## COMMITTEE OF ADJUSTMENT REPORT SUMMARY MINOR VARIANCE APPLICATION FILE NUMBER A030/22

AGENDA ITEM NUMBER: 6.5	Thursday, May 26, 2022
APPLICANT:	Rajeshkumar & Jignasa Patel
AGENT:	J-R Home Designer Inc.
PROPERTY:	30 Mary Natasha Ct Kleinburg
ZONING DESIGNATION:	See below.
VAUGHAN OFFICIAL PLAN	Vaughan Official Plan 2010 ('VOP 2010'): "Low-Rise Residential"
(2010) DESIGNATION:	
RELATED DEVELOPMENT	None
APPLICATIONS:	
*May include related applications for minor variance, consent, site plan, zoning	
amendments etc.	
PURPOSE OF APPLICATION:	Relief from the Zoning By-law is being requested to permit the construction of a proposed cabana and installation of a pool and related equipment to be located in the rear yard.
	I .

## COMMITTEE OF ADJUSTMENT REPORT MINOR VARIANCE APPLICATION A030/22

AGENDA ITEM NUMBER: 6.5	CITY WARD #: 1
APPLICANT:	Rajeshkumar & Jignasa Patel
AGENT:	J-R Home Designer Inc.
PROPERTY:	30 Mary Natasha Ct Kleinburg
ZONING DESIGNATION:	See below.
VAUGHAN OFFICIAL PLAN	Vaughan Official Plan 2010 ('VOP 2010'): "Low-Rise Residential"
(2010) DESIGNATION:	
RELATED DEVELOPMENT	None
APPLICATIONS:	
*May include related applications for minor	
variance, consent, site plan,

A1 - Title Sheet & Site Plan

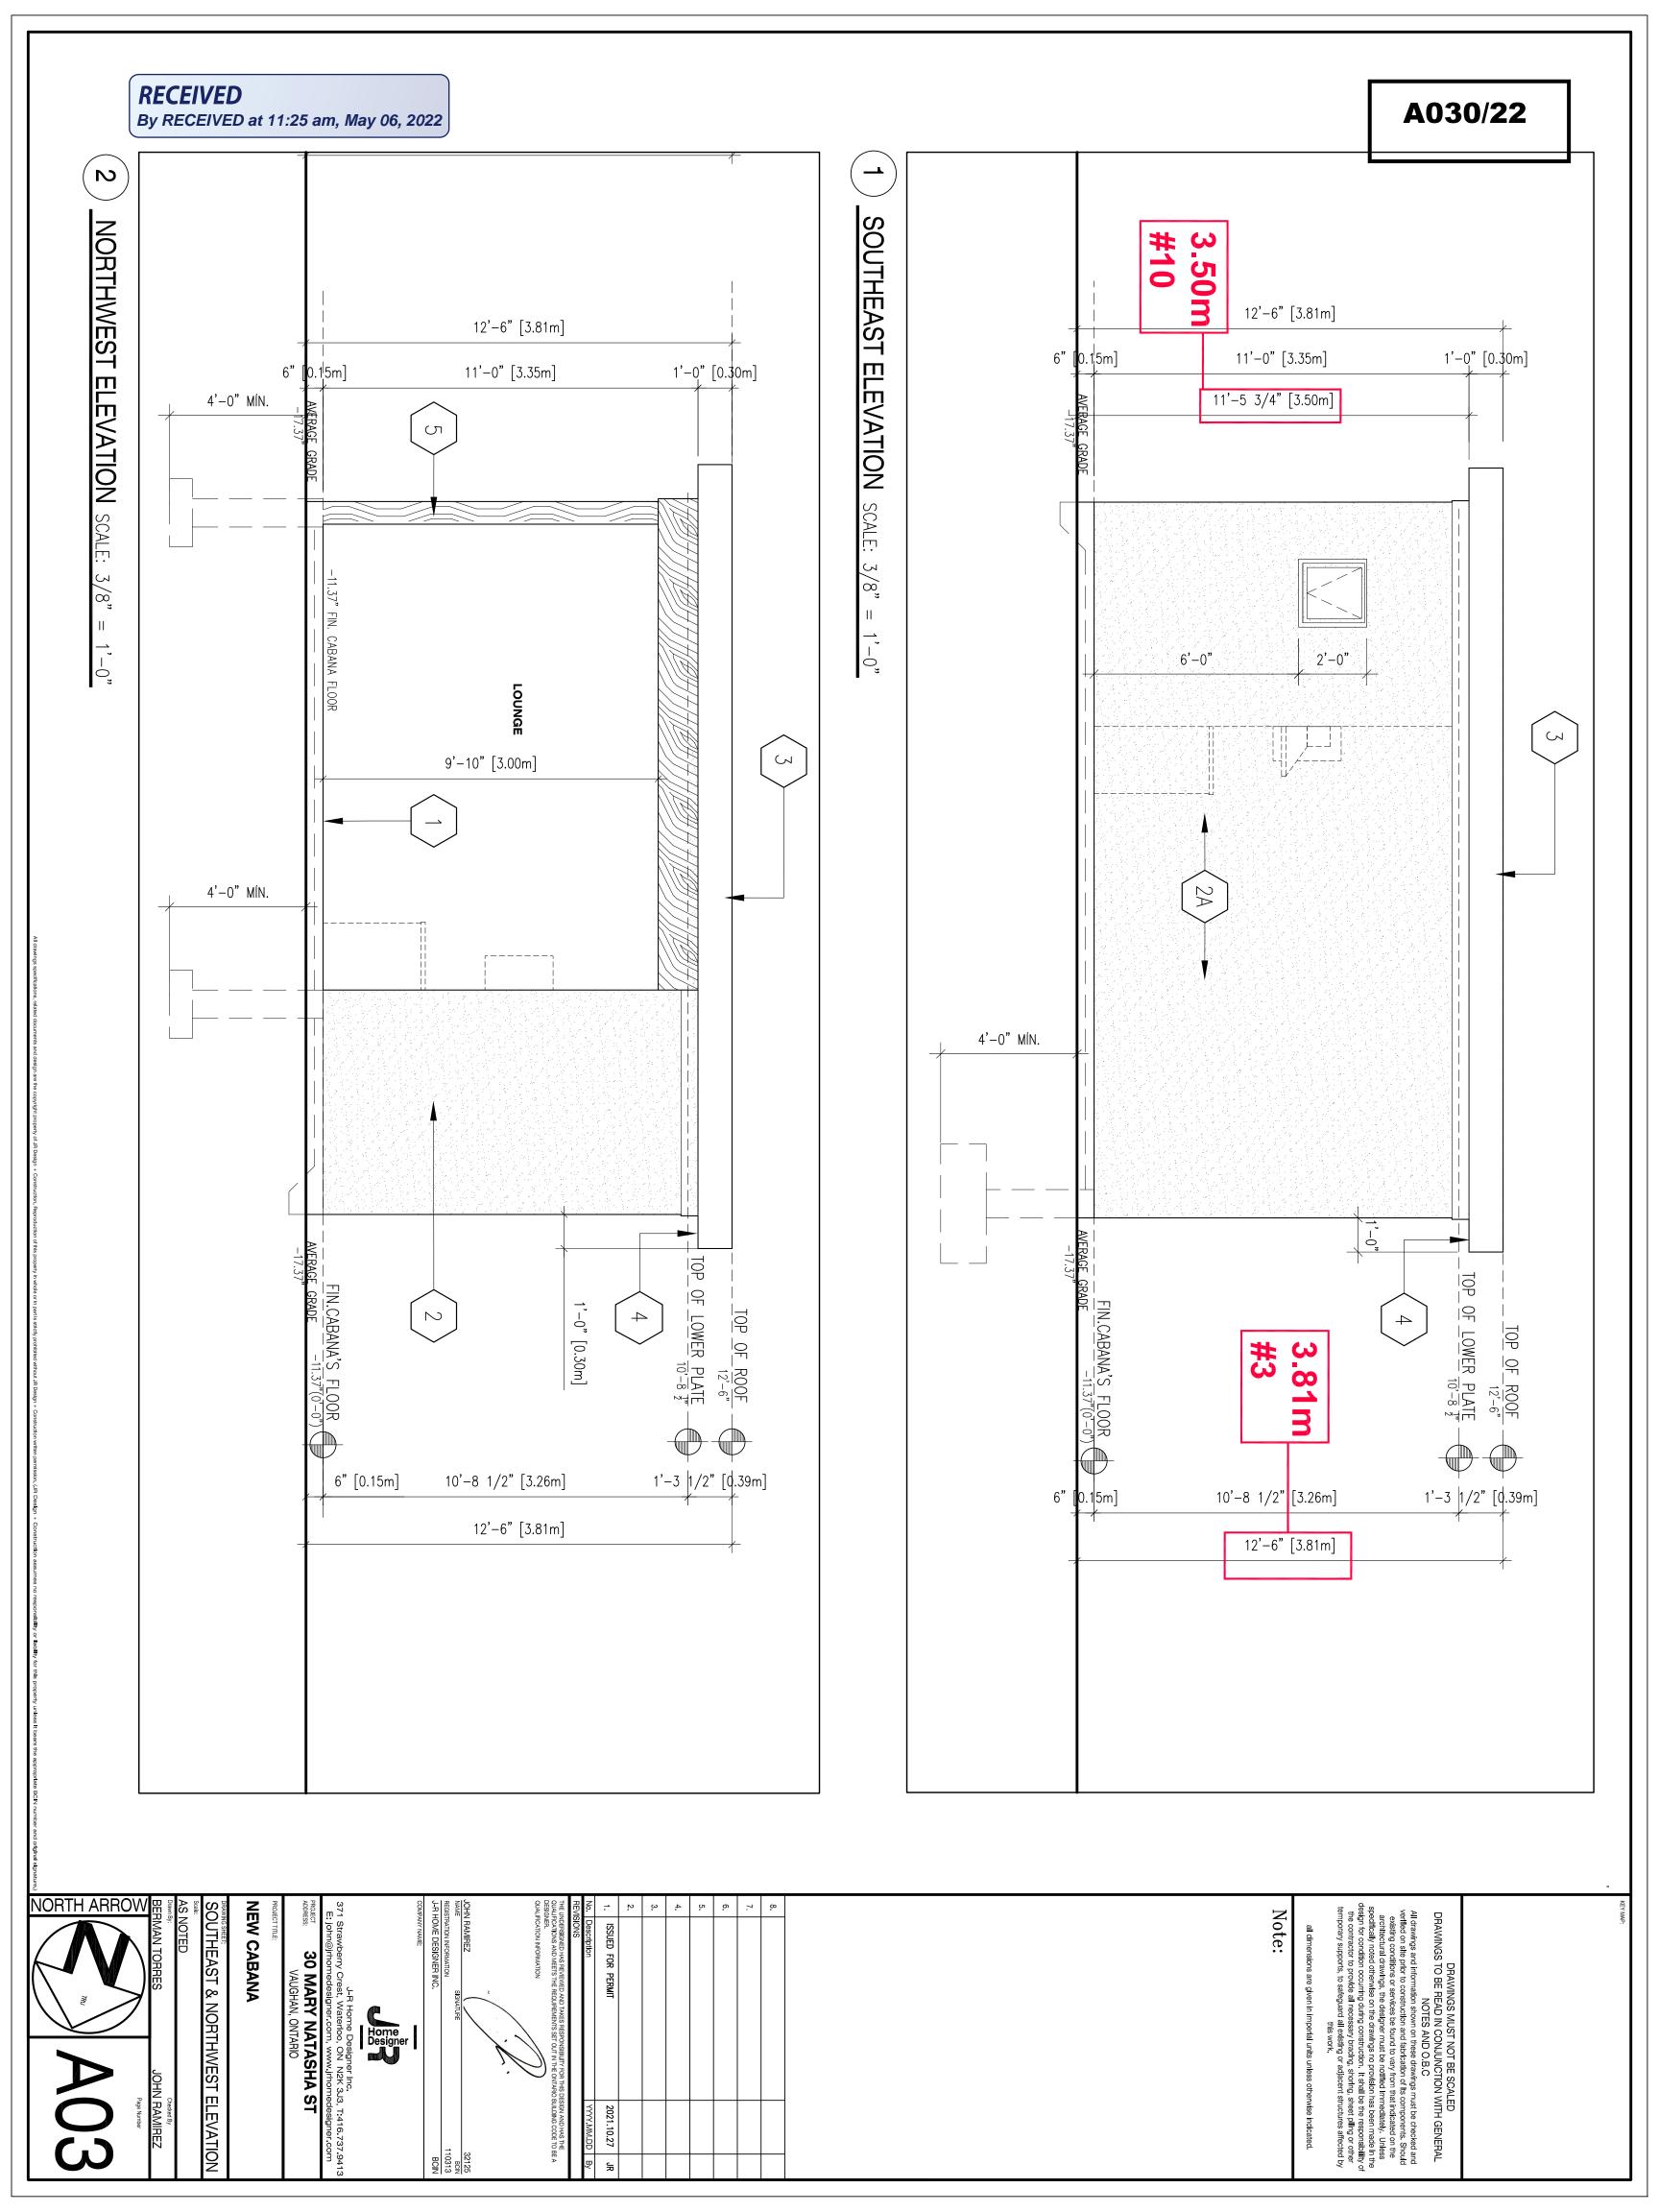
The typical required setback for the pool equipment pad is 0.6m from the property line but the proposed set back is 0.32.m. The applicant has proposed to install weeping tiles to the north side of the property line near the pool equipment pad to facilitate drainage

The Development Planning Department has no objection to Variances 1 and 6 as the reduction to the rear yard setback is consistent with previous approvals in the neighbourhood and will not impact the abutting properties. The rear yard setback of 0.94 m also maintains an appropriate area for access and drainage.

The Development Planning Department has no objection to Variance 2 as the reduction to the interior side yard setback is minor in nature and will not have adverse impacts to the neighbouring property. The interior side yard setback of 0.76 m also maintains an appropriate area for access and drainage.

The Development Planning Department has no objection to Variance 9 as access to the rear yard will be maintained through the southern side yard. The Development Engineering Department has also reviewed the proposal and is satisfied that drainage will be maintained through the introduction of weeping tiles.

- 2. The owner/applicant shall provide a brief to demonstrate the appropriate LID (Low-impact Development) measures and show the measures taken in the drawing to the satisfaction of DE to address the deceased soft landscaping from 60% to 39% in order to mitigate potential impacts on the municipal storm water system. The owner/applicant also need to install weeping tiles to the north side of the property line, near the pool equipment pad to facilitate drainage.
